This document lists the new features and bugfixes available in the new LumiNode firmware.

RELEASE NOTES LUMINODE 2.1.1

Updated LCD, showing active redundancy.

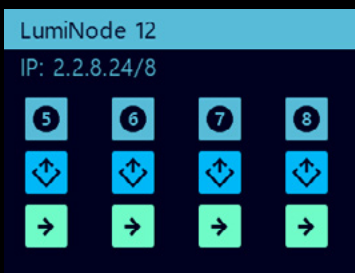
DMX REDUNDANCY

- Set a DMX output port as redundant slave port. This allows you to make a redundant (ring) connection with your DMX devices.
